**Johnston County Public Schools
HVAC CONTROLS REPLACEMENTS – PACKAGE 5**

ADDENDUM NO. 2

DATE: December 14, 2023

PROJECT: Johnston County Public Schools
Controls Replacements – Package 5

OM-502

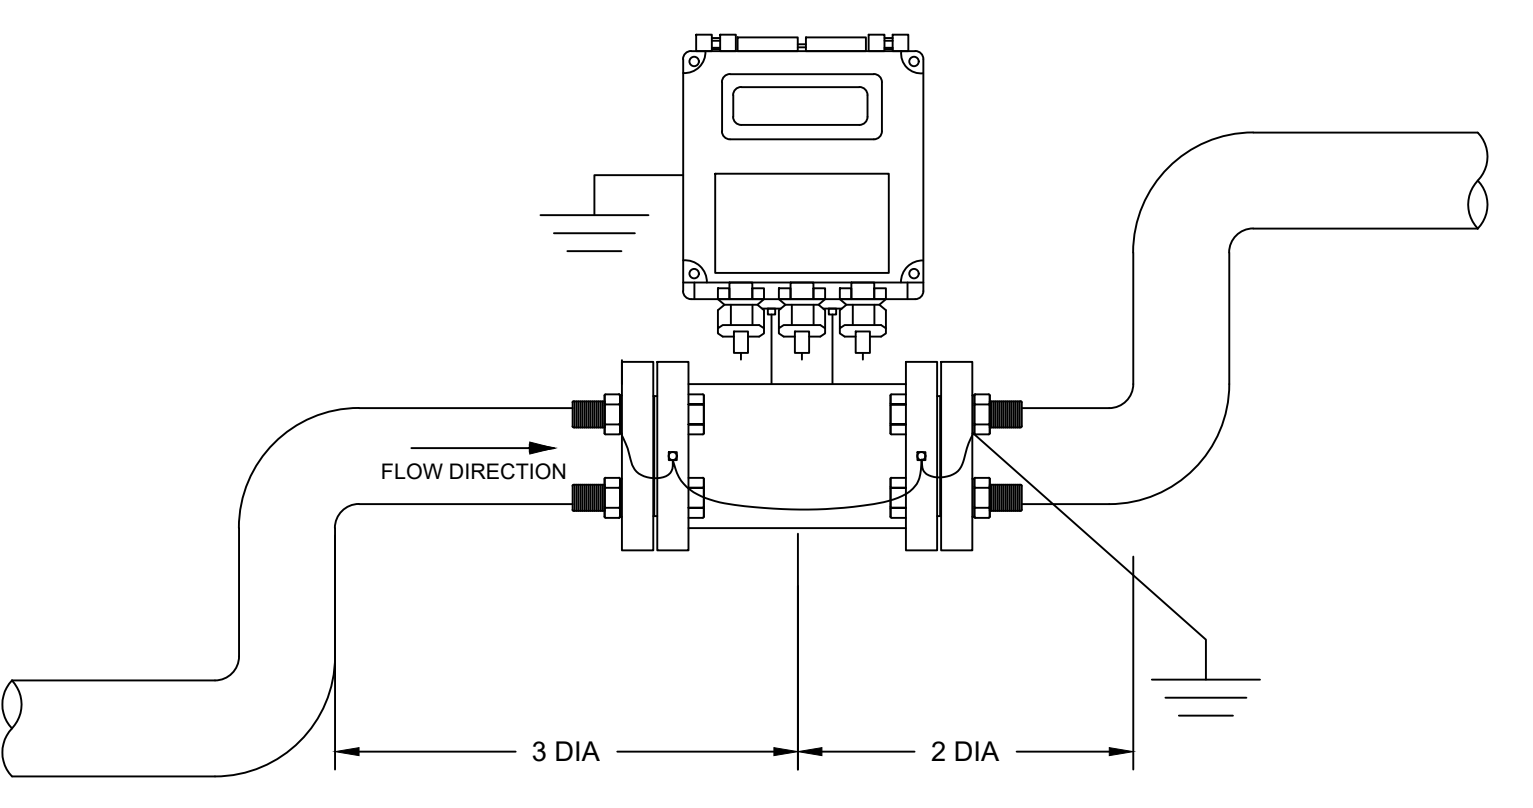
1. Sheet 0G-001 – Sheet added.
2. Sheet 0M-502 – New sheet for added details.
3. Sheet 0M-720 – Added Gymnasium timer switch to SOO
4. Sheet 1ME-201 – Keynote removed.
5. Sheet 1M-601 – Flowmeter and Air Systems schedules adjusted.
6. Sheet 2ME-204 – Keynote removed.
7. Sheet 2M-601 – Air System schedule adjusted.
8. Sheet 2M-603 – Flowmeter schedule adjusted.
9. Sheet 3ME-204 – Keynote removed.
10. Sheet 3M-601 – Air System schedule adjusted
11. Sheet 3M-603 – Flowmeter
12. Sheet 4ME-201 – Keynote removed.
13. Sheet 4ME-204 – Keynote removed.
14. Sheet 4M-601 – Air System schedule adjusted
15. Sheet 4M-603 – Flowmeter schedule adjusted

BALANCE EXISTING MANUAL BALANCING VALVE (CIRCUIT SETTER) TO 5 GPM EACH (APPROXIMATELY 3 PER SCHOOL) TYPICALLY NEAR THE END OF EACH CLASSROOM WING. PROVIDE CHANGE ORDER TO REPLACE WITH AUTOMATIC BALANCING VALVE (FLOW LIMITER) IF EXISTING CIRCUIT SETTER IS INOPERABLE FOR APPROVAL BY ENGINEER.

INSTALL VIA MANUFACTURER'S INSTALLATION INSTRUCTIONS INCLUDING BUT NOT LIMITED TO STRAIGHT RUN AND GROUNDING REQUIREMENTS.

1 END OF LINE MINIMUM FLOW BYPASS

2 IN-LINE FLOW METER INSTALLATION
